# Great Wilsey Park, Haverhill

## Designers Response to Road Safety Audits for Access Strategy off Chalkstone Way

**Great Wilsey Park development, Haverhill, Suffolk :  
Chalkstone Way roundabout**

**Road Safety Audit  
Stage 1**

Figure 2a: Alternative Chalkstone Way Access

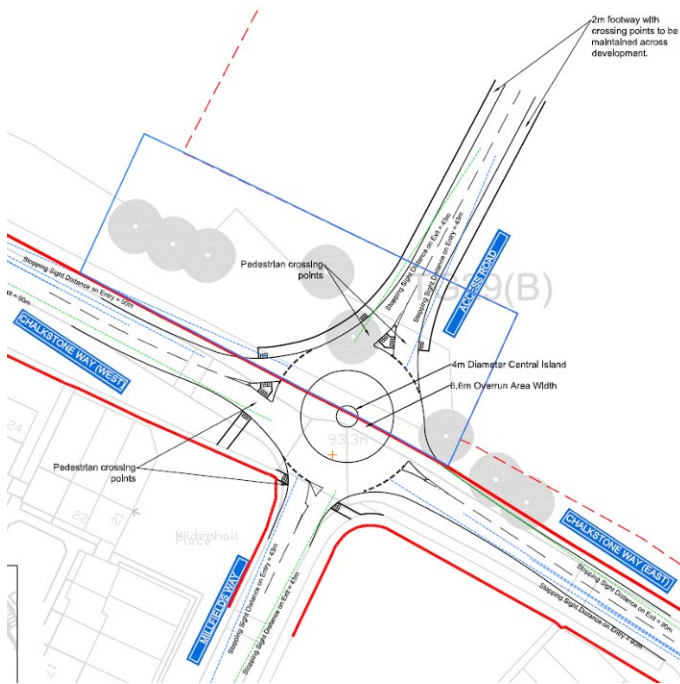
#### **Problem 1: Inadequate deflection on vehicle paths**

**Location:** Eastern and northern arm approaches to the roundabout.

**Summary:** The design layout of the roundabout is such that there is potential for failure to give way on entry resulting in straight-ahead collisions with roadside furniture or side-impact or shunt type collisions.

For the roundabout entry from the east (Chalkstone Way) the entry path curvature is in the region of 140m and for the roundabout entry from the north the entry path curvature is in the region of 100m, both using the over-run area edge as the vehicle path guide. Such potential approach paths give inadequate entry path curvature to fully-prevent traffic from entering the roundabout at too high a speed or having to resort to late-braking (DMRB standard TD16 also refers).

The drawings do not show any traffic calming measures on the development Access Road. Whilst the Auditors do acknowledge that Chalkstone Way is a traffic-calmed road the situation could be hazardous to cyclists, particularly in view of the wide overall circulatory carriageway width as associated with all compact roundabout layouts that are designed to accommodate specific large/long vehicle types, not all of which type might use the subject roundabout and approach roads.

- The roundabout should be re-designed to ensure that vehicle entry paths have radii tighter than 70m radius (such re-design might involve the provision of a larger roundabout); and
- Traffic calming should be applied to the development Access Road.

#### **Problem 2: NMUs**

The footway from the development ends at the north-western quadrant with pedestrians having to cross Chalkstone Way to gain access to the existing footway along the southern side of Chalkstone Way. Not far west of the proposed roundabout is the Westfield Primary Academy school so the Auditors would expect some NMU demand between the development (the Access Road roundabout) and the school which is not catered for in the current proposals unless such trips cross and re-cross Chalkstone Way.

The recommendation is that the footway along the western side of the development Access Road should be continued on to the school entrance not far west of the proposed roundabout with, perhaps, enhancement to shared cyclist/pedestrian status.

#### **Problem 3: Bus stop location**

The existing bus stop west of the roundabout is located only approx. 25m ahead of the roundabout 'Give Way' line and the drawing has no indications of bus stop relocation.

The recommendation is that the bus stop should be relocated further west, sufficiently away from the roundabout.

#### **Problem 4: Speed cushion feature**

There is an existing speed cushion arrangement immediately west of the roundabout located only approx. 15m ahead of the roundabout 'Give Way' line and the drawing has no indications of its removal. With a roundabout so close the speed cushion

arrangement would appear superfluous and could safely be removed – however, ‘Problem 1’ relates in respect of speed control on the roundabout approaches.

The recommendation is that the speed cushion arrangement should be relocated a short distance further west.

**Designer's Response:** *The Auditors comment about the deflection has been duly noted but is to be challenged. Using TD16 Guidance, the Designer cannot achieve the Auditors quoted under-provision for deflection.*

*However, and in positive response, the roundabout approach arms have been verified as compliant with TD16 and have received minor realignment to achieve the optimal deflection.*

*The matter of traffic calming measures for the development access road is duly noted. However, this is a matter of detail and as such will be addressed at the Reserved Matters stage and subject to the Stage 2 Road Safety Audit.*

***Designer's Response:** The existing footways which run to the south of Chalkstone Way are 2m which is adequate width for pedestrians, they have been considered and incorporated into the design. All internal NMU routes are incorporated within the parameters plan and road hierarchy, which will be developed in detail as part of the detailed application. The footways shown replicate the existing footway alongside Chalkstone Way. Due to design constraints posed by third party land ownership issues, it is not viable to continue the footway west along the north side of Chalkstone Way to the proposed development.*

***BCL Response:** It is difficult to deduce from either DMRB, Manual for Streets or Local Transport Notes where a bus stop should be positioned in relationship to a roundabout. However, it is known from TD 16/07 that a pedestrian crossing should not be positioned between 20m or 60m on entry to a roundabout. Given that a stationary bus would encourage a motorist to stop just like a pedestrian crossing would, the same principle shall be applied here. Therefore, the bus stop is advised to be relocated to be 60m west of the roundabout.*

*Designer’s Response: It is difficult to deduce from either DMRB, Manual for Streets or Local Transport Notes where a speed cushion should be positioned in relationship to a roundabout. However, it is known from TD 16/07 that a pedestrian crossing should not be positioned between 20m or 60m on entry to a roundabout. Given that a speed cushion would encourage a motorist to slow down just like a pedestrian crossing would, the same principle shall be applied here. Therefore, the speed cushion is advised to be relocated to be 20m west of the roundabout.*
